Work Order ID 153225

Item ID: D4766-041 Accept ***N900040100*** Setup Start ***NS1***
 Revision ID: Stop ***NS2***
 Item Name: Skidtube Assembly
 Start Date: 11/11/2016 Start Qty: 1.00 ***1*** Cust Item ID:
 Required Date: 11/14/2016 Req'd Qty: 1.00 ***1*** Customer:
 Reference:

D4766-041 SKIDTUBE

A	NEW ISSUE	AP	13.02.13
REV.	DESCRIPTION	BY	DATE
DESIGN	AP	DART AEROSPACE USA, INC. EUGENE, OR	
DRAWN	AP		
CHECKED	AJS	DRAWING NO.	REV. D
MFG APPR.	DD	D4766	SHEET 1 OF 6
APPROVED	WM	TITLE	SCALE
DE APPR.	DS	SKIDTUBE	NTS
DATE	15.11.02	COPYRIGHT © 2014 BY DART AEROSPACE USA, INC. THIS DOCUMENT IS PRIVATE AND CONFIDENTIAL AND IS SUPPLIED ON THE EXPRESS CONDITION THAT IT IS NOT TO BE USED FOR ANY PURPOSE OR COPIED OR COMMUNICATED TO ANY OTHER PERSON WITHOUT WRITTEN PERMISSION FROM DART AEROSPACE USA, INC.

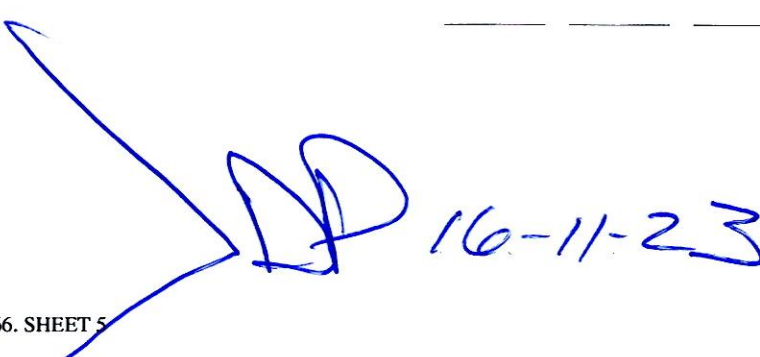
1- Open 7th x-bolt holes from ~~0.5~~ to 0.750".
****FOR WEB ALIGNMENT PURPOSES ONLY****
DWG D4766 SHEET 4 DETAIL K.

D4766-045 SKIDTUBE SUB ASSY
(ASSEMBLY DETAIL)

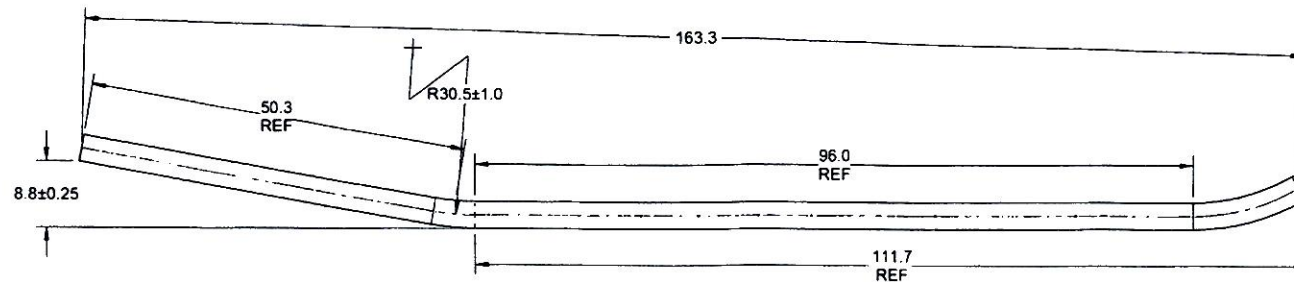
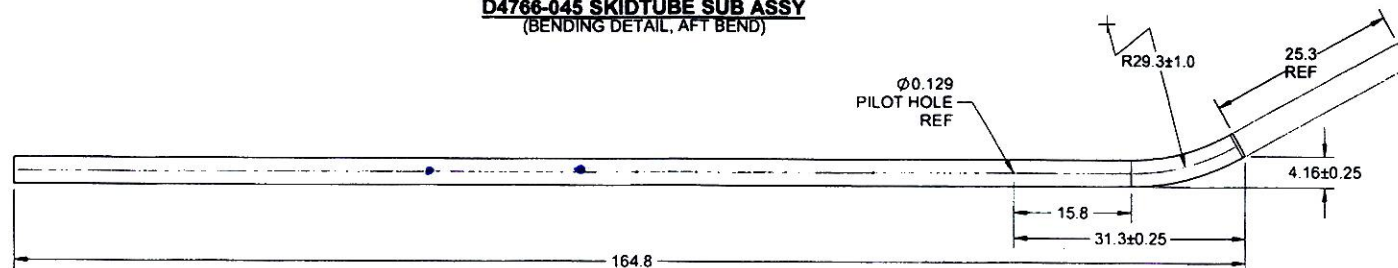
Typo, should read!
35.9" 9/14/11/21

***NOTE, 35.877" FROM AFT END AS PER DWG D4766. SHEET 5
